WREXHAM COUNTY BOROUGH COUNCIL PLANNING COMMITTEE
MEETING OF 3 SEPTEMBER 2018

REPORT OF THE
HEAD OF ENVIRONMENT AND PLANNING

Pages 46 – 49 LLA P/2018/0433

8 Crown Place, Llay, Wrexham
FOR: Mr Ian Griffiths (Applicant)

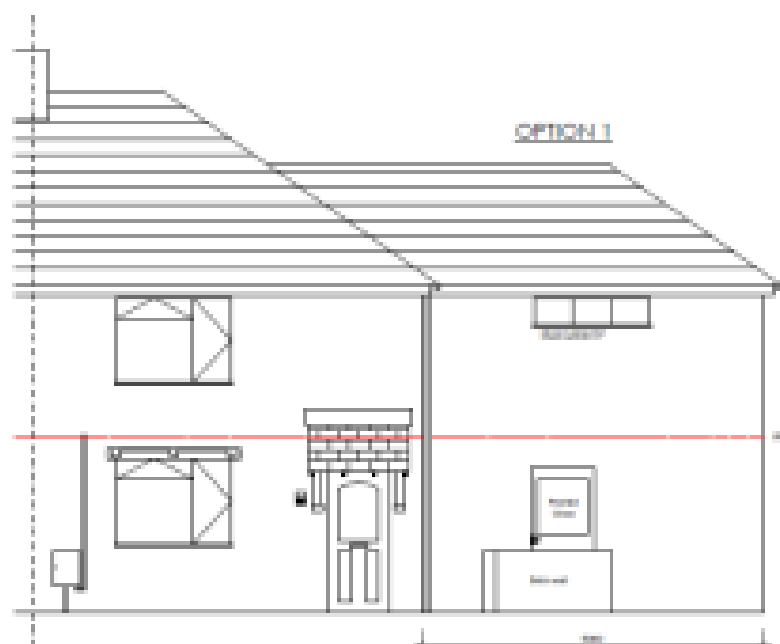
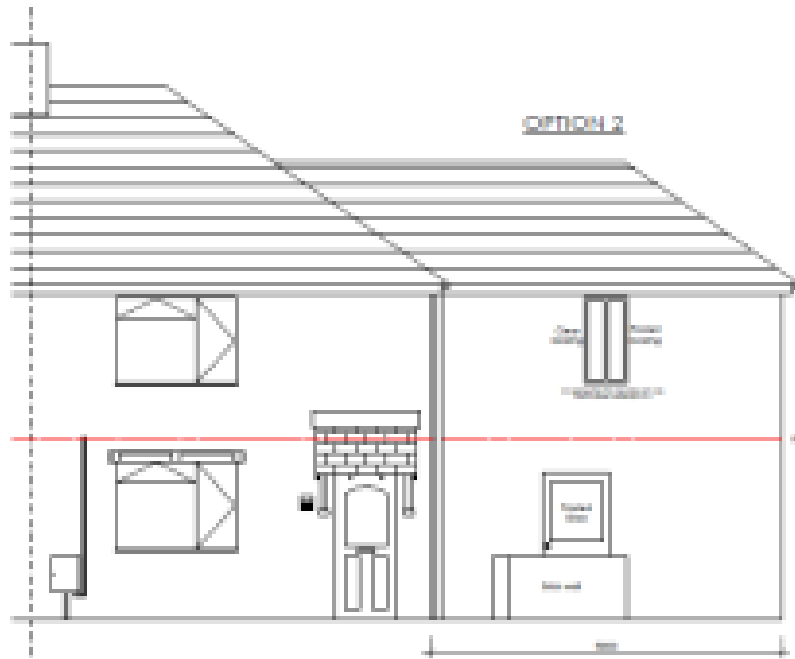
In relation to the photographs provided by the applicant, it is maintained that the site is still visible when viewed from the street scene and public realm.

The majority of residents at Crown Place are considered would have full sight of the extension given their location either opposite, adjacent to or at the end of the cul-de-sac therefore the extension and dwelling as a whole is considered would be visible when viewed from various points in the street.

In terms of the photographs of the building under construction, I believe this is the side elevation of a building rather than the front elevation.

The ground floor of Options 1 and 2 above is considered appears discordant and at odds with the appearance of the main dwelling, comprising what the applicant has described as an entrance door with frosted glazing. It is unclear as to what the portion of brick wall at the bottom of the door is.

The high level windows in Option 1 and oriel window in Option 2, whilst are considered may overcome the overlooking impacts into the first floor window of the neighbouring property, are considered would look at odds in relation to the appearance of the main dwelling and site as a whole.

The alternative options are not considered would have overcome the visual and residential amenity impacts identified in the reasons for refusal.
